**ASI-0104**

## Supplementary Info.

Subject: TM-281A MARS/CAP Modification Date: September 7, 2011

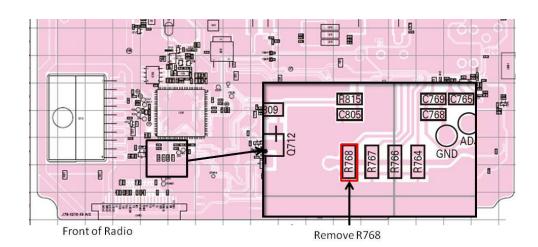
- 1. Turn off the transceiver and disconnect the antenna and DC supply.
- 2. Remove the screw on each side of the top panel.
- 3. Remove the top cover as shown below.
- 4. Locate and **carefully** remove Chip Resistor R768 on the TX/RX Board.

Note 1 - Be careful not to damage the ribbon cable from the Display Board to TX/RX Board. You may need to move the ribbon cable out of the way to remove the chip resistor. This can be easly done by taping the ribbon cable to the front panel of the radio.

Note 2 – It is recommended that you use 2 soldering irons to remove this resistor to avoid damage to the PCB foils.

### **Transmitter Operating Range:** 136 ~ 174MHz
